**Origination Form**  
Proposed Revisions to a Standard Plans Index

| <b>Originator:</b> | Meyer, Ronald and Lemus, Vivian | <b>Index Number:</b>    | 700-120                             |
| <b>E-mail:</b>     | Ronald.Meyer@dot.state.fl.us    | <b>Index Title:</b>     | ENHANCED HIGHWAY SIGNING ASSEMBLIES |

| LAST<br>REVISION<br>11/01/26 | REVISION | DESCRIPTION: |  FY 2027-28<br>STANDARD PLANS | ENHANCED HIGHWAY SIGNING ASSEMBLIES | INDEX<br>700-120 | SHEET<br>6 of 12 |

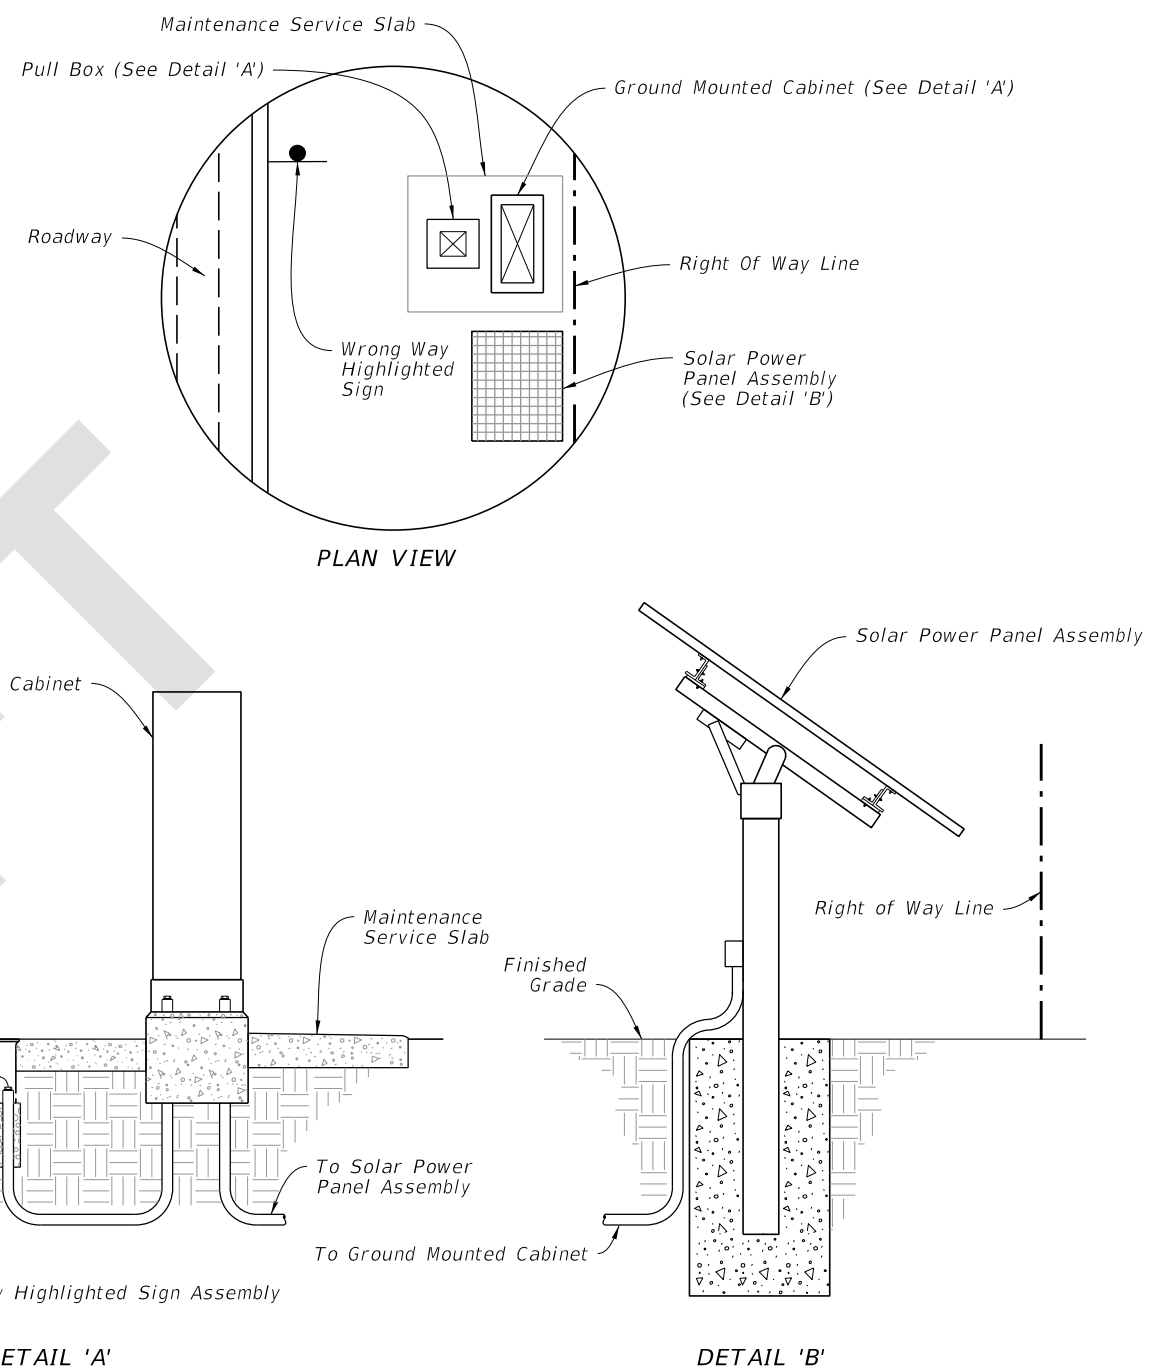
Sheet 7 (New Sheet 6): Added "(As Required)" to the 12" Yellow Flashing Beacon callout; Deleted dimensions for R2-1; Updated the "Electronic Speed Feedback Sign" to "W13-20aP Vehicle Speed Feedback Plaque; Updated the "Your Speed" sign to match the shape and size of the W13-20aP Vehicle Speed Feedback plaque as required and shown in the latest MUTCD; Changed Note 2 - "Install the Vehicle Speed Feedback Plaque in accordance with Specification 700 and 995".

Sheet 7 - (New Sheet 6) must be updated to better match the shape and size of the W13-20aP plaque as required and shown in the latest MUTCD. The TERL has been in contact with speed feedback sign vendors listed on the APL regarding both standalone signs and plaques. Vendors are aware of the MUTCD changes and their need to comply with MUTCD requirements to have products listed on the APL. Note 2 - reflect the reference to SHS and MUTCD

1. Type A6 Assembly (conventionally powered) is shown.  
Type B6 Assemblies (solar powered) similar.
2. Install the Vehicle Speed Feedback Plaque in accordance with Specifications 700 and 995.
3. Foundation reinforcement not shown.
